Comments on “Iran’s Ballistic Missile Potential”: A Paper by David Montague, Uzi Rubin, and Dean Wilkening

By David Holloway[†] and Theodore Postol^{*}

Figure 2

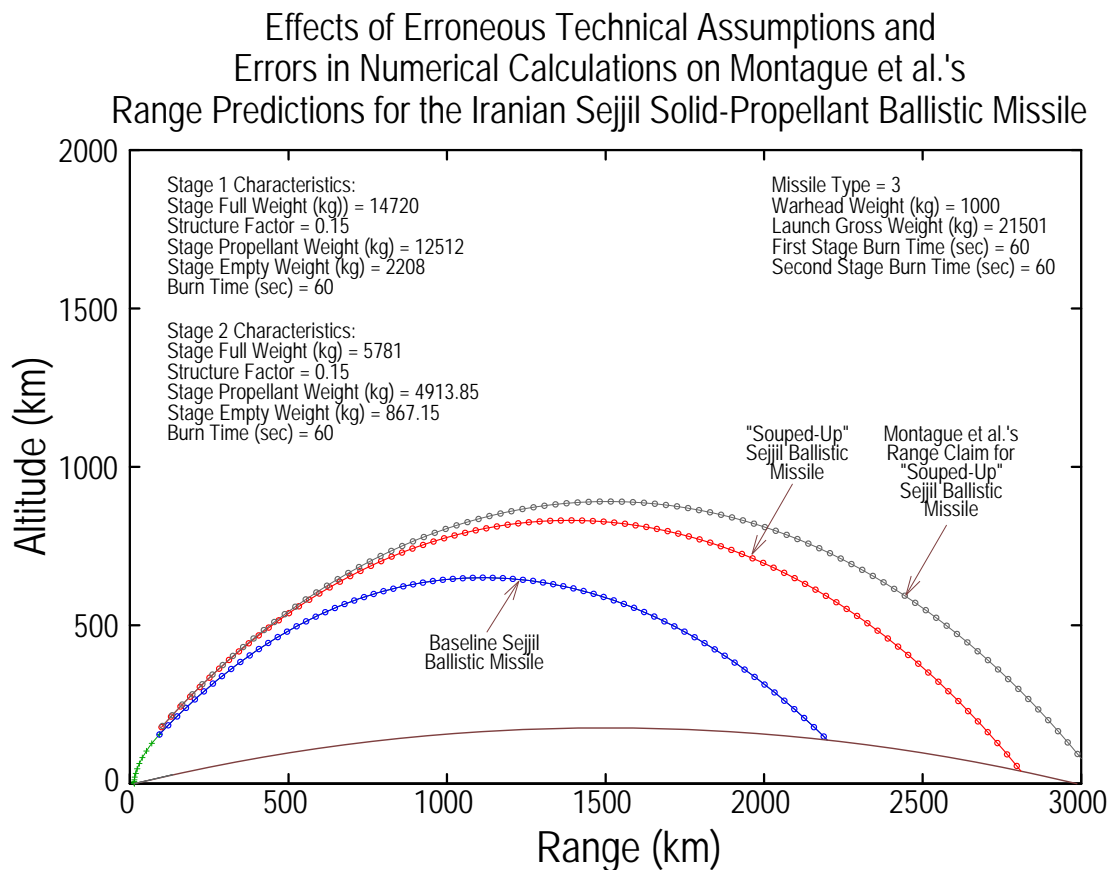
Figure 2 below shows the flight trajectory of our Baseline Sejgil for a non-rotating earth. Montague et al. report their missile ranges for a rotating earth and a trajectory azimuth of 310 degrees (this trajectory goes from the northwestern corner of Iran to slightly south of Ireland). If we assume a rotating earth on the same azimuth, the range of our Baseline Sejgil missile, which is the same as the one used by Montague et al., is roughly 2000 km. The rotating earth-range reported by Montague et al. of the baseline Sejgil is 2500 kilometers. Hence, the range Montague et al. calculate for our Baseline Sejgil is essentially 25 percent larger than the range we calculate using *exactly the same model missile!* This indicates that Montague et al.'s basic calculations of range and payload are wrong by a factor of 20 to 25 percent, independent of the erroneous hidden assumptions about technology improvements used in their calculations.

Figure 2 shows the flight trajectory of the Baseline Sejgil if we assume that it is built with rocket technologies that Montague et al. assert could be readily incorporated into it; those technologies would produce their Sejgil 3 (with the rocket parameters shown in Table 2). If Montague et al.'s assertions about

readily achievable advances in rocket technology were correct, the Baseline Sejjil recently flown by Iran could be quickly improved to a "souped-up" Sejjil that had a nearly 30% gain in non-rotating earth-range – an increase in range from about 2200 km to more than 2800 km.

However, Montague et al.'s rotating-earth range for our Baseline Sejjil was 2500 km, indicating that the non-rotating-earth range that Montague et al. report for our Baseline Sejjil is about 2700 km, rather than the 2200 km non-rotating earth-range in our Report for the Baseline Sejjil. Montague et al.'s "souped-up" Sejjil has a range of 2800 km relative to the 2200 km range of our Sejjil. Since Montague et al. have errors of 25% in their range calculations, they will get a non-rotating-earth range of $1.25 \times 2800 = 3500$ km for the "souped up" Sejjil. Adjusting for the roughly 200 km loss in range due to the earth's rotation, we conclude that Montague et al. would calculate a rotating-earth range of roughly 3300 km for their souped-up Baseline Sejjil.

Thus, if Montague et al. are to be believed, the current Baseline Sejjil should be able to achieve a range improvement of greater than 50% *simply* by incorporating into the existing missile the technologies they assume for their postulated Sejjil 3!

Figure 3

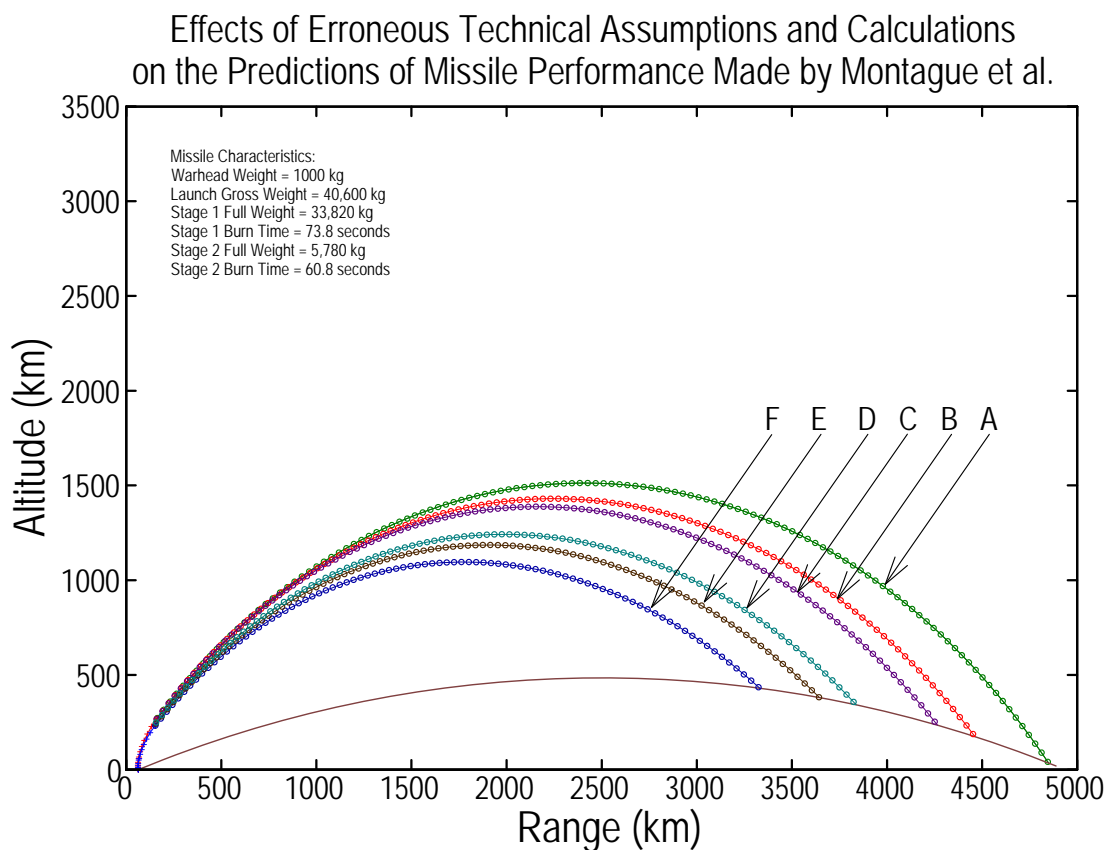
Step 4: Figure 3 and Table 3 quantify the performance contributions for each of the new rocket technologies assumed by Montague et al. to lead to the range and payload improvements they incorrectly claim for their postulated Sejjil 3.

Missile A is Montague et al.'s postulated Sejjil 3 missile, except that it is assumed that the propellant in the second stage has a specific impulse of 285 seconds, rather than the 270 second specific impulse assumed by Montague et al. The rotating-earth range for this missile, which is the range that would be reported by Montague et al., is less than 4700 km.

Missile B is Montague et al.'s postulated Sejjil 3. It has a non-rotating-earth range of 4500 km and a rotating-earth range of 4265 km. Assuming that such a rocket could be built, its range would be 15 percent less than that claimed by Montague et al.

Missile C assumes that the second stage of Montague et al.'s postulated Sejjil 3 has the same specific impulse as the first stage (262 seconds). Missile C has a rotating-earth range of 4075 km, 20% lower than that claimed for the postulated Sejjil 3.

Missile D is further modified to have a missile casing that weighs the same as a steel casing, rather than the filament-wound casing implied by the choice of a structure factor of 0.88 assumed by Montague et al. for their postulated Sejjil 3. Missile D has a rotating-earth-range of 3645 km, 35% below that claimed for the Sejjil 3.

Missile E is further modified to have a specific impulse of 256.5 seconds for both the first and the second stages. This is a realistic estimate of the potential gain in specific impulse that could *theoretically* be achieved if it were simple, as *wrongly* claimed by Montague et al., to remove the jet vanes and substitute a hydraulic swiveling rocket nozzle for control of the missile. When the *proper theoretical* increase in specific impulse is used, the rotating-earth range of Missile D is 3465 km, 40% lower than the postulated Sejjil 3.

Missile E is Montague et al.'s postulated Sejjil 3 with parameters (i.e. structure factors and rocket motor specific impulses) identical to those achieved in the Baseline Sejjil missile that was tested by Iran on May 20, 2009. This missile has a rotating-earth range of 3165 km, 55% less than the range claimed by Montague et al for their postulated Sejjil 3!
